*Application No. 10/756,979*

**REMARKS/ARGUMENTS**

Appl. No. 10/756,979  
Amdt. Dated April 6, 2006  
Reply to Office Action of Jan. 06, 2006  
Annotated Sheet Showing Changes

**BEST AVAILABLE COPY****Fig. 3****Fig. 4**

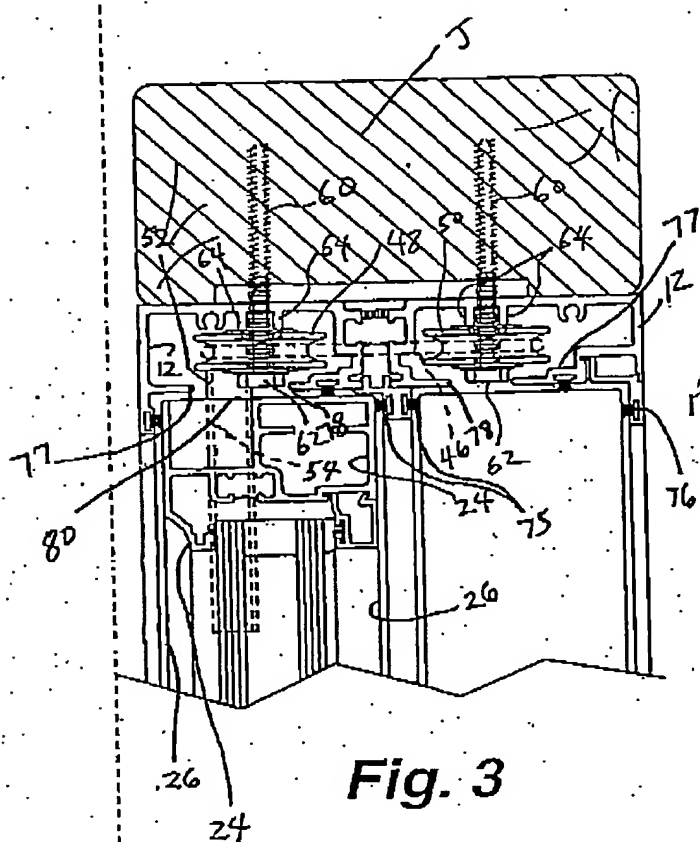
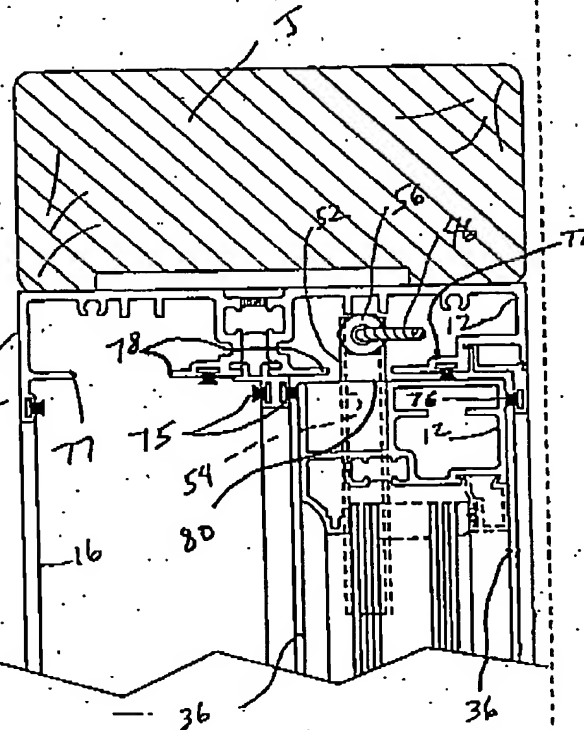
In Claims 1,7, and 8 have been amended to further distinguish over the reference of record. Claim 1 has been amended to further recite that the channels are defined by a pair of exterior frame elements and an intermediate frame element position between the pair of exterior frame elements, and said intermediate frame elements separating said pair of channels. Claim 1 has also been amended to further recite that one pulley of said pair of pulleys are mounted in one channel of said pair of channels, and the other pulley of said pair of pulleys being mounted in the other channel of said pair of channels, said pulleys being laterally offset from and separated from lateral edges of the sashes. The Description and Figures have been amended to particularly point out the claimed exterior frame elements, intermediate frame elements, and lateral edges of the sashes. Specifically, reference number 77 corresponds to the claimed exterior frame elements, reference number 78 corresponds to the claimed intermediate frame element, and reference number 80 corresponds to the claimed lateral edges of the sashes. Figures 3, 4, and 5 clearly

Concurrently filed herewith is a request for approval of the annotated drawing changes which add reference numbers 77, 78, and 80.
